Date: 10 May 2017
To: Thai Aviation Services Limited
Regarding: TR PCR Inboard Bolt Too Long
Technical Case #: C0051988
Attn: Grant Robinson

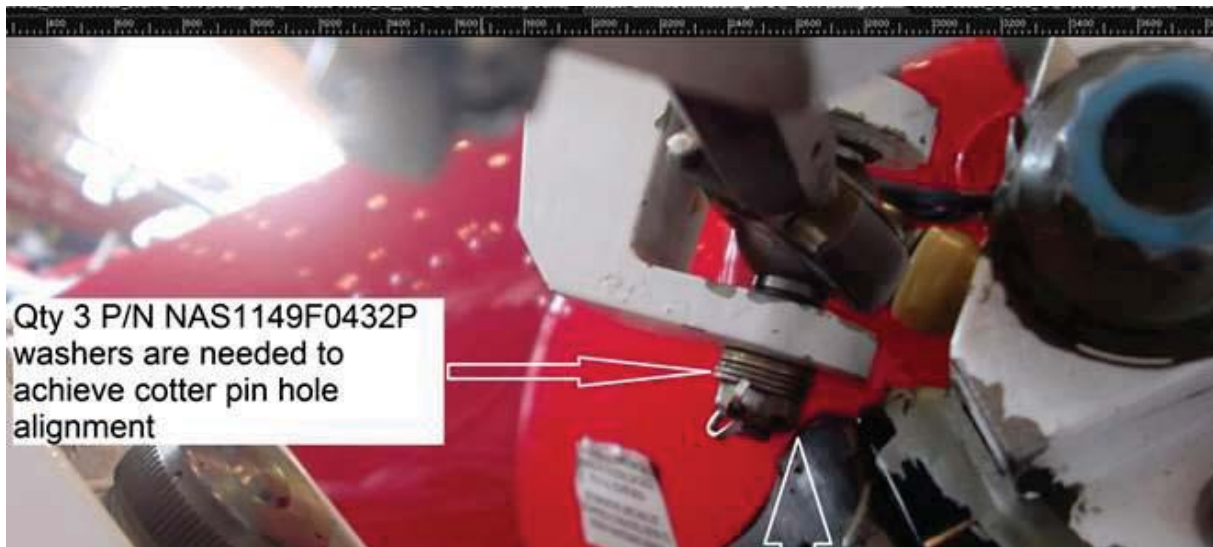
On January 30, it was documented that TAS maintainers noted very tight clearance between the nut on the Tail Rotor Pitch Link bolt (inboard) and the Tail Rotor Boot.

TAS had found that the -26D bolt length typically required Qty 3 NAS1149F0432P thin washers to line up the cotter pin hole, leaving the P/N MS17826-4 nut within 0.010 inches or less of contacting the TR boot, even under static conditions.

This suggested to TAS that the bolt was too long.

TAS requested Sikorsky Engineering approval to use the shorter NAS1104-24D bolt for the inboard TR PCR attachment for all S-76D's in the TAS fleet via technical case# C0051988.

Please confirm T/R Pitch Link Bolt stack-up per Sikorsky drawing 76101-06000 Rev. F screenshot below.

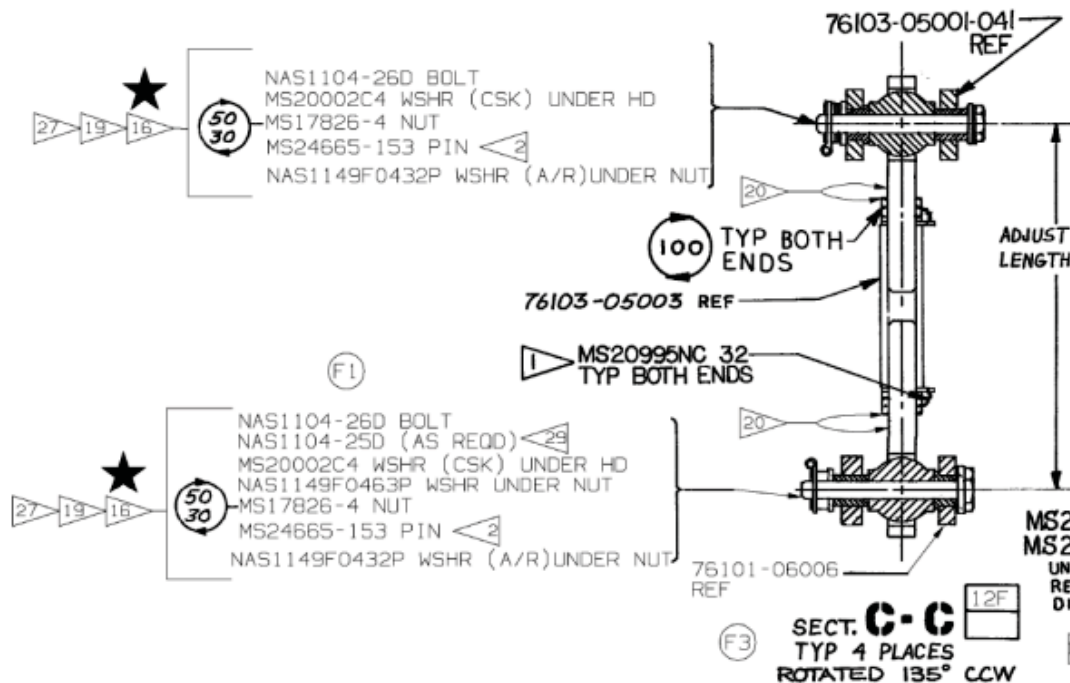
Review of the drawings at that time, indicated that TAS was installing the bolt backwards, which was the cause of the close tolerance between the boot of the adjacent blade and the nut.
The horn has a straight bushing on the "outside" (towards the adjacent blade boot) and a flanged bushing on the "inside". The install drawing showed the bolt head being installed at the straight bushing side, with the washer stack-up and nut on the "inside". It was communicated through the case resolution that when the bolt was installed in the correct orientation, there should be adequate clearance between the bolt head and the boot of the adjacent blade.
We then recommended the customer to correct the installation of these bolts on all S-76 aircraft in their fleet.

The NAS1104-24D bolt originally requested by the TAS cannot be used, because the stack-up calculation indicates it is too short.

On May 8, a revision to 76101-06000 was released, which now allows the shorter NAS1104-25D bolt to be used in place of the NAS1104-26D bolt for this application only.
